**Staff Report and Comments
Cedar Grove Property
8200 Gillead Road, Huntersville
Application for COA HLC315**

New Greenway restroom at existing greenway parking lot. Parking lot has previously received COA.

McDowell Creek Greenway Restroom: Cedar Grove Property

Site Plan

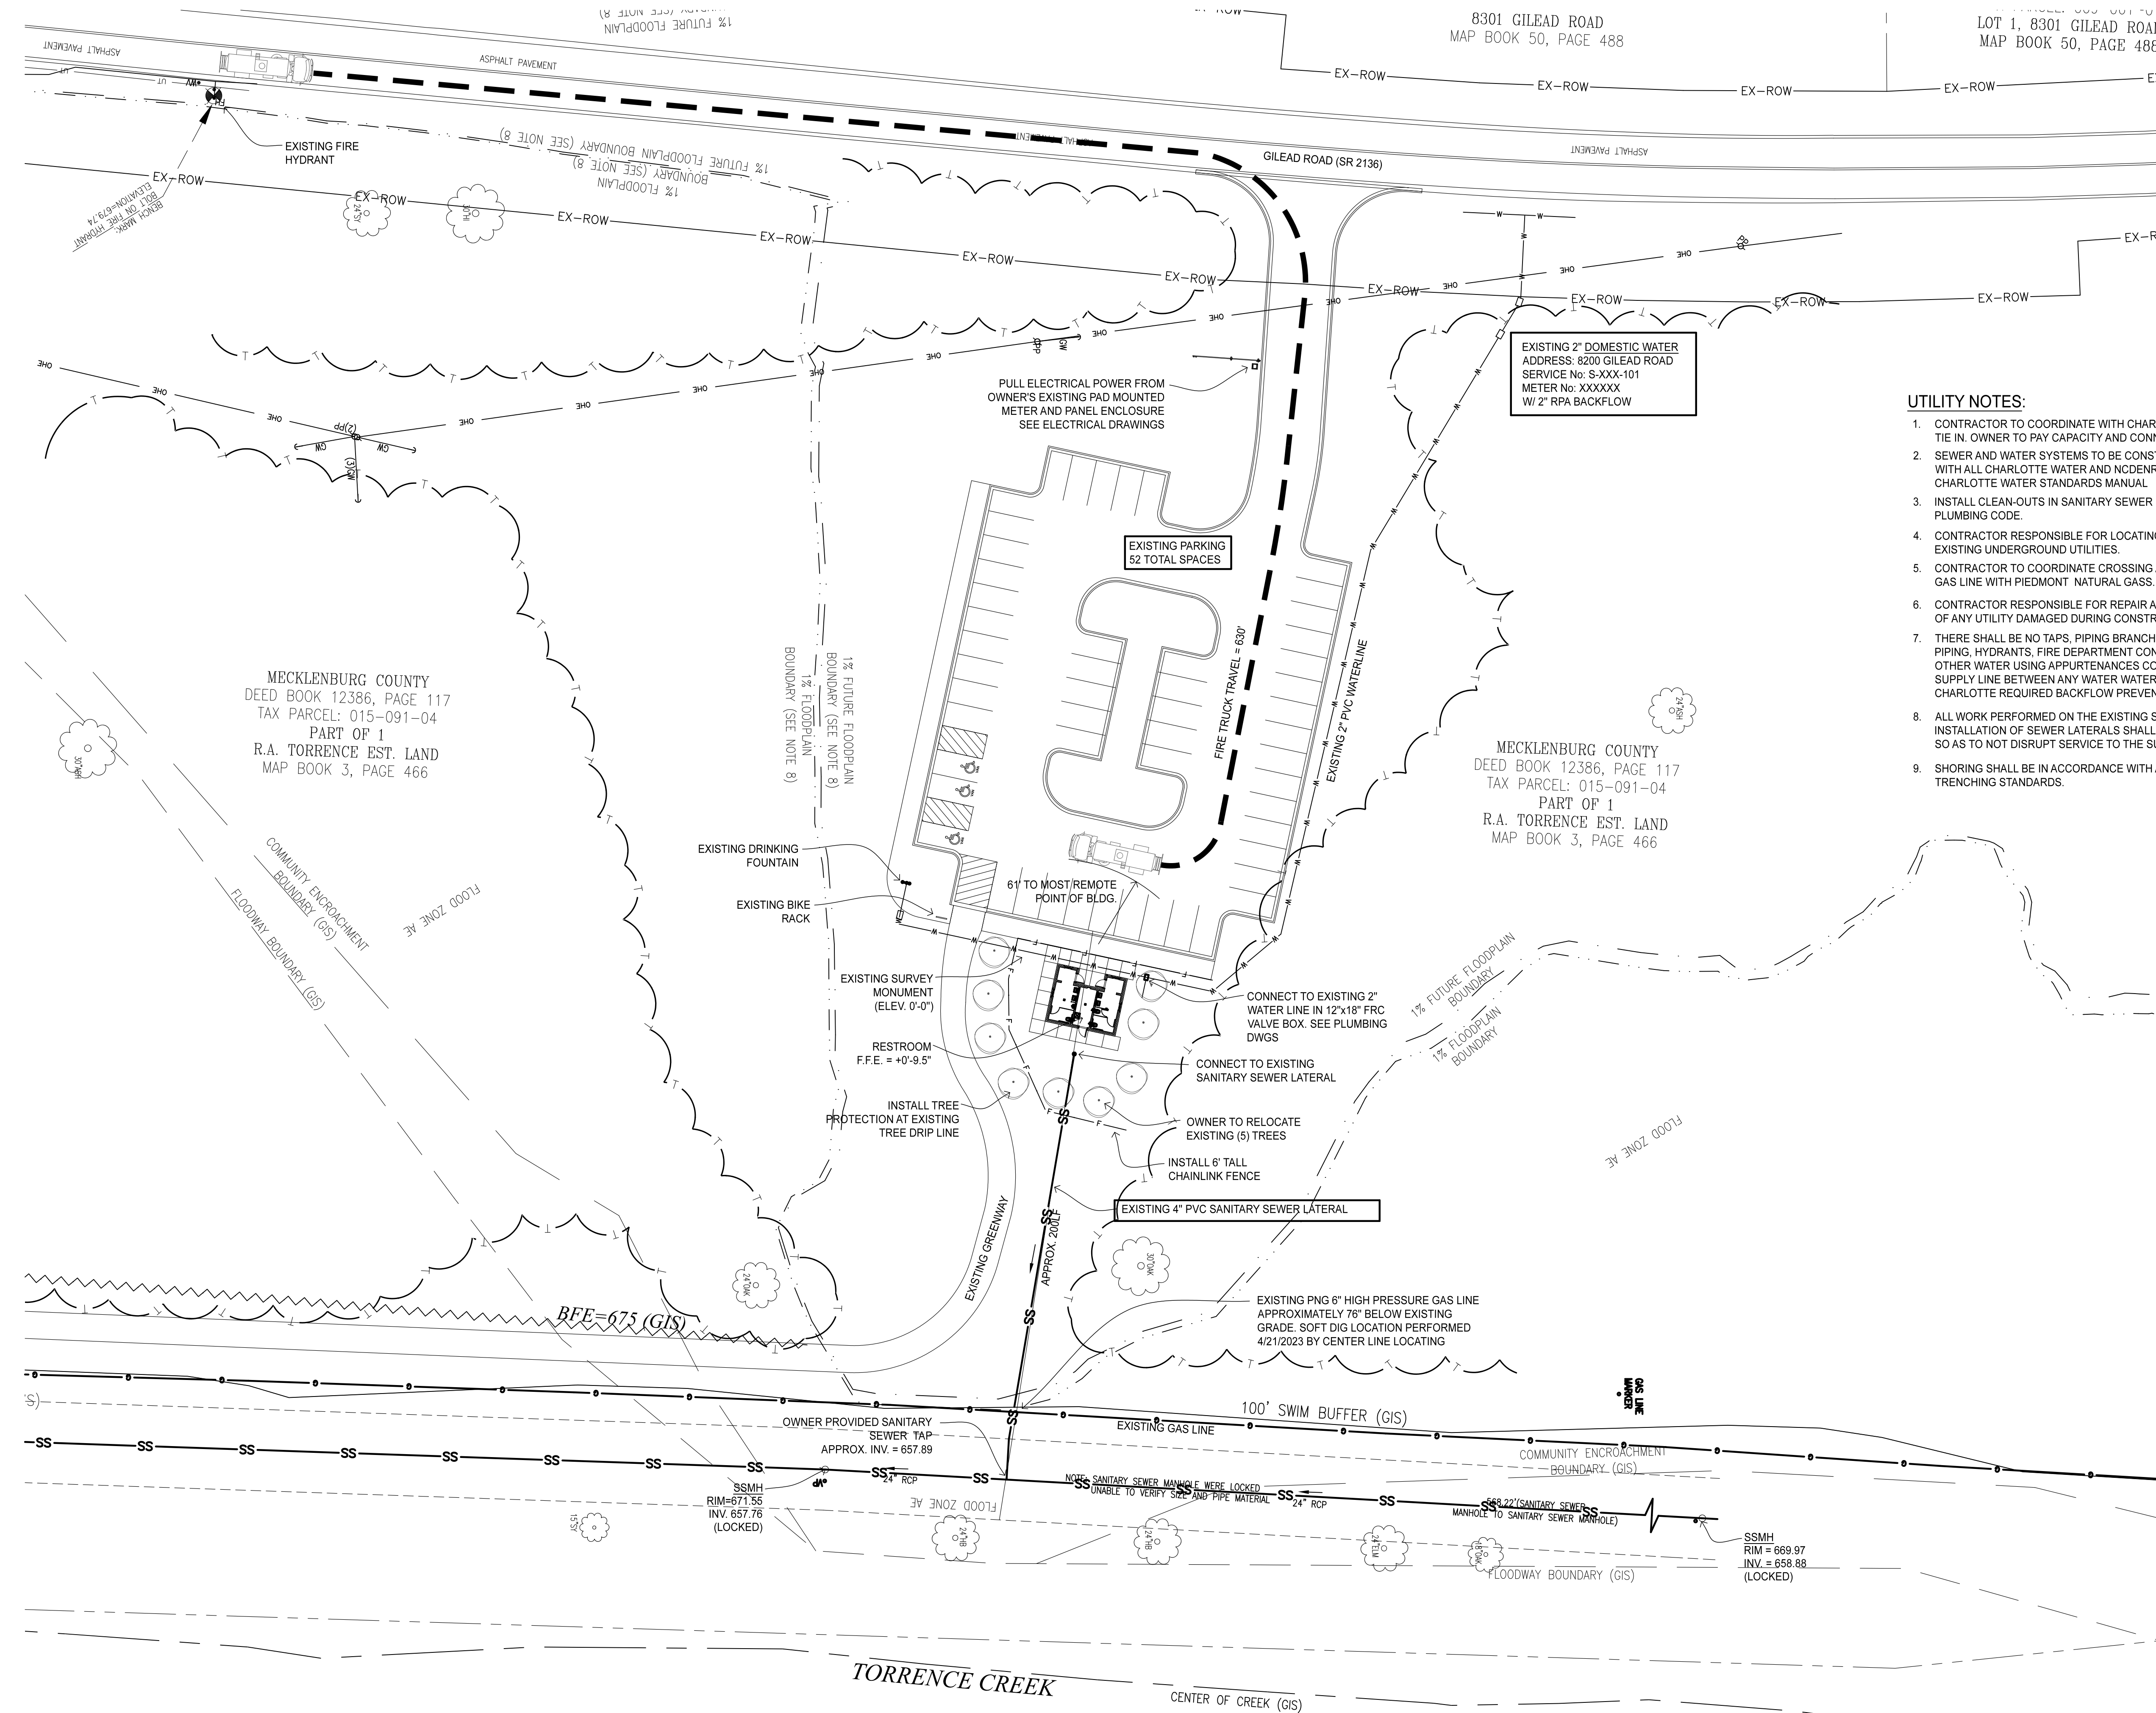
1. The proposed restroom, adjacent to an existing paved parking lot and 300' from Gilead Rd, should not have a significant negative impact to the historic property in regard to HLC Standard 2. From Gilead Rd the impact of the restroom is reduced by its deep setback. The negative impact on the rest of the historic property is reduced as the restroom is clustered with another incongruous feature, the parking lot.
2. The project meets HLC Standards 9 and 10 as it does not destroy historic materials that characterize the property, and could be removed in the future without damaging any historic features that characterize the property.

Staff suggests that the Commission approve the application as shown.
